Reference: L-2015-011116-A

Subject: Jericho Rise Wind Farm Noise Impact Assessment
Updated Sound Contour Plots

This letter may be considered an addendum to Report 2015-062515-B.

Project: Jericho Rise	Description: Plot 1	Legend: Turbine Location Non-Participating Residence
Prepared for: EDR	Predicted Sound Contours (dBA) Plotted to "Conservative" Impact Threshold of 40 dBA. All Units Operating Under 6 m/s Wind Conditions.	
Date: January 27, 2016	Drawing #: JR-Rev-H-1-1-1

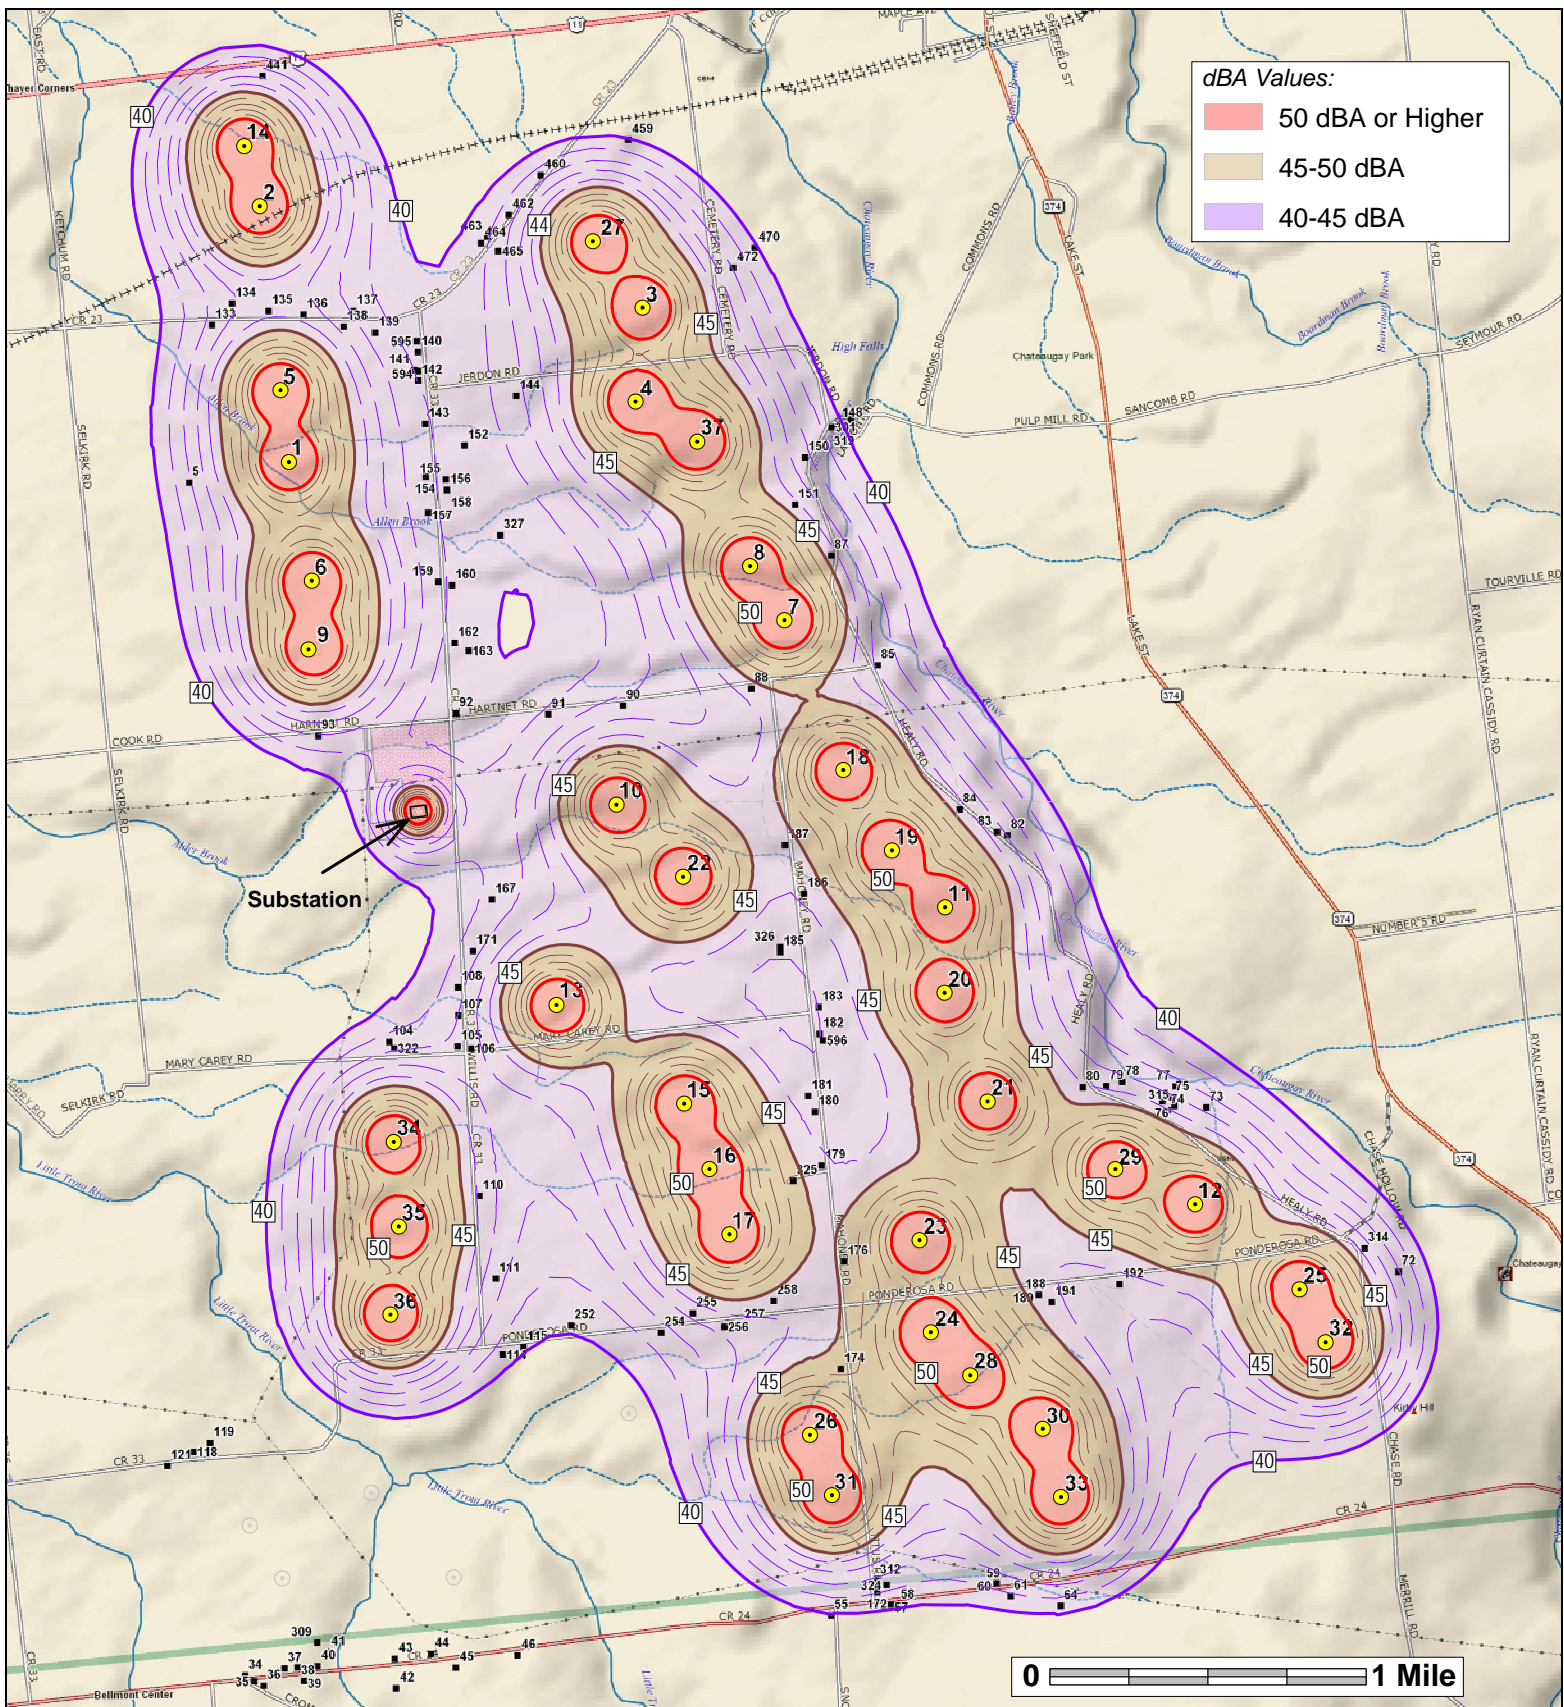
The most significant change involves the elimination of the six alternate units that were included, for conservatism, in all previous model iterations and that are still mentioned in latest assessment report (HAI Report 2015-062515-B, dated October 23rd, 2015). The alternate turbine locations were simply place holders in the event a turbine was moved from another location to one of the alternate spots. In the current model the sound contours and nominal impact thresholds for each design case are considerably contracted in the southwestern corner of the project area where 5 of the 6 alternate locations were. Obviously, the anticipated noise impact in that area is considerably reduced by the removal of the alternate units.

Although some of the other units moved slightly, none of the shifts has significantly changed the sound level at any residence; consequently, the expected noise impact described in the assessment report for the ‘conservative’ and ‘typical’ design cases remains the same along with all of our general conclusions. In addition, the updated layout continues to demonstrate compliance with the local noise limit of 50 dBA at all non-participating residences.
